Access Compliance Report

Public Rights-of-Way

Intersection ID: N/A	Main Street: HUNTER_CREST_LN	Cross Street: WOODLAWN_RD	Location: SE
ADA ID: 829F683212BE	Ramp Type: PerpDiag	Initial Pass/Fail: Fail	Overall Compliance: No
		Severity Score: 10

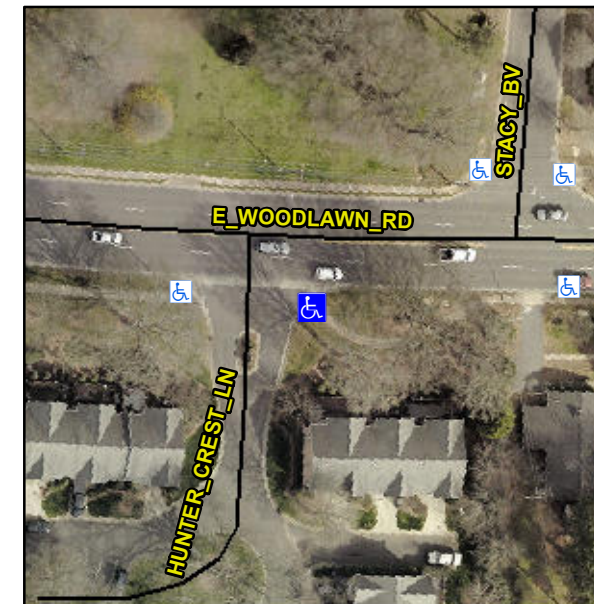
Not Found, R304.5.1, R304.5.3

Compliance	Description	Data	Compliance	Description	Data
N/A	Ramp Length (in)	65.0	Yes	Ramp Slope (%)	6.8
No	Ramp Width (in)	41.0	No	Ramp XSlope (%)	2.7
N/A	Flare Type LT	N/A	N/A	Flare Type RT	N/A
N/A	Flare Slope LT (%)	N/A	N/A	Flare Slope RT (%)	N/A
N/A	Flare Traversable LT?	N/A	N/A	Flare Traversable RT?	N/A
N/A	Landing Length (in)	N/A	N/A	DWS Provided?	N/A
N/A	Landing Width (in)	N/A	N/A	DWS Contrast?	N/A
N/A	Landing Slope (%)	N/A	N/A	DWS Length (in)	N/A
N/A	Landing X Slope (%)	N/A	N/A	DWS Full Width?	N/A
N/A	Landing Curb? (Y/N)	N/A	N/A	DWS Offset (in)	N/A
N/A	Shared Landing?	N/A			
N/A	Gutter Ponding?	N/A	N/A	Gutter Slope (%)	N/A
N/A	Gutter Lip Ht (in)	N/A	N/A	Gutter X Slope (%)	N/A
N/A	Painted X Walk1?	No	N/A	Painted X Walk2?	No
	X Walk 1 Direction	To N		X Walk 2 Direction	To W
N/A	X Walk 1 Width (in)	N/A	N/A	X Walk 2 Width (in)	N/A
	X Walk 1 Slope (%)	8.2		X Walk 2 Slope (%)	2.6
	X Walk 1 X Slope (%)	0.9		X Walk 2 X Slope (%)	6.7

Remove & Replace Curb Ramp With Two New Directional Ramps or Equivalent.
